Permit Application Review Report
Date: 1/21/2026

Project Name: TSC Ham Lake, MN

Project PAN: P-25-037

Project Purpose: Construction of a new commercial building with parking and associated stormwater treatment features

Figure 2: Site Plan

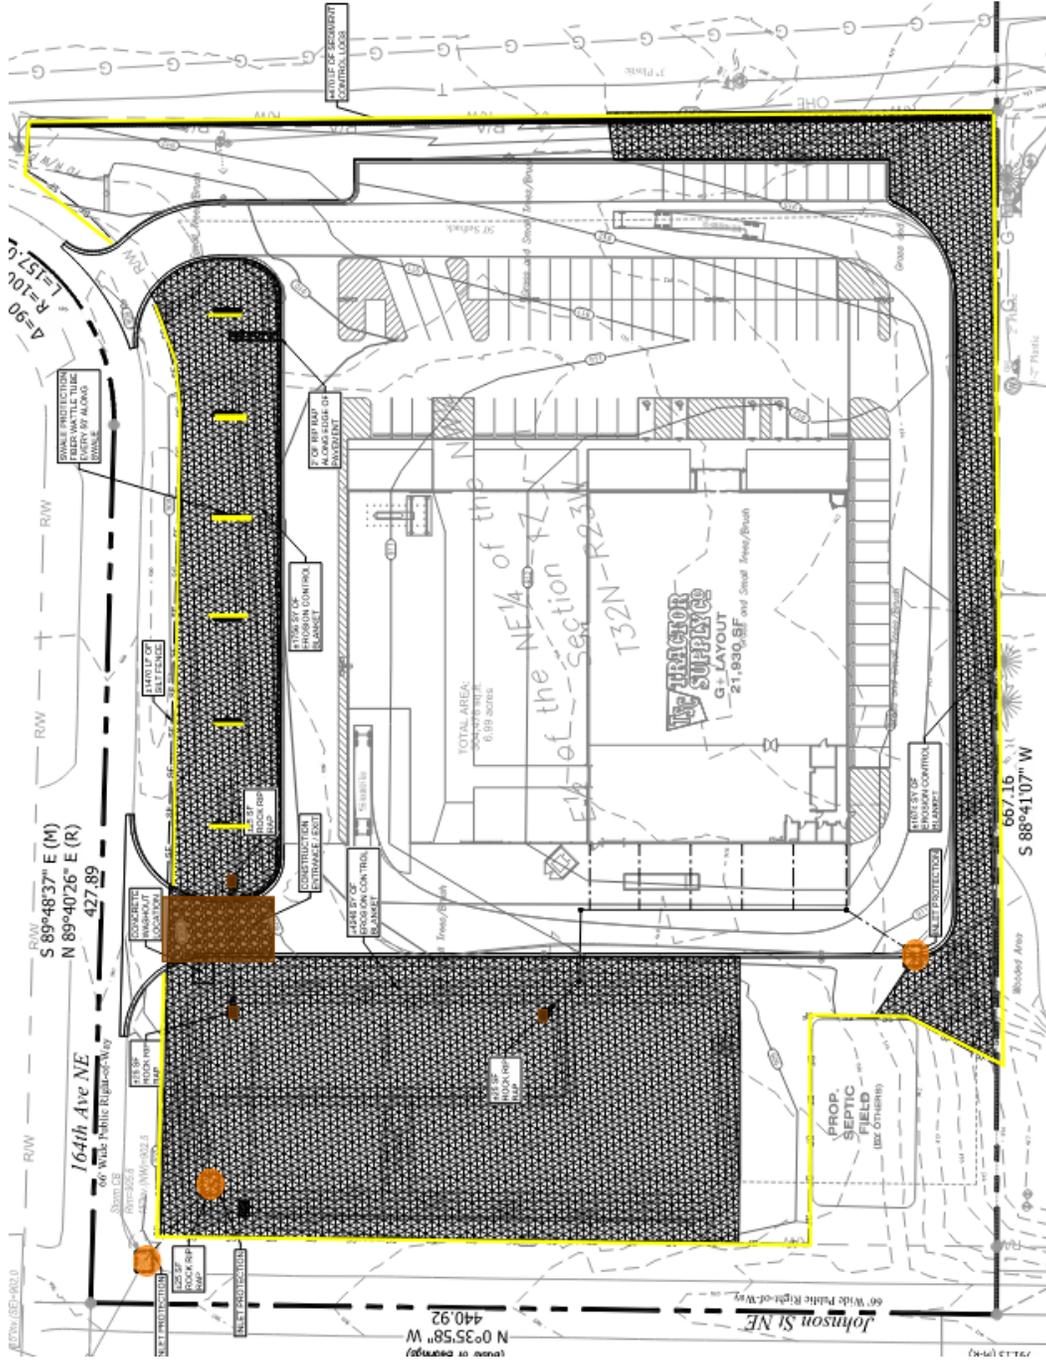
Description: The applicant is proposing the construction of a new commercial building with parking and associated stormwater management features. The project will disturb 5.03 acres and create 3.02 acres of regulated impervious surface. The parcel drains to County Ditch 58. The relevant water resource concerns are stormwater management and soils and erosion control. These correspond to District Rules 3 and 4. See attached Figure 1: Project Location and Figure 2: Site Plan.

The Untreated drainage area is a small portion of the drive entrance that cannot be routed to the treatment basin. The volume control standard has been met to the maximum extent practicable as shown in Table 2.
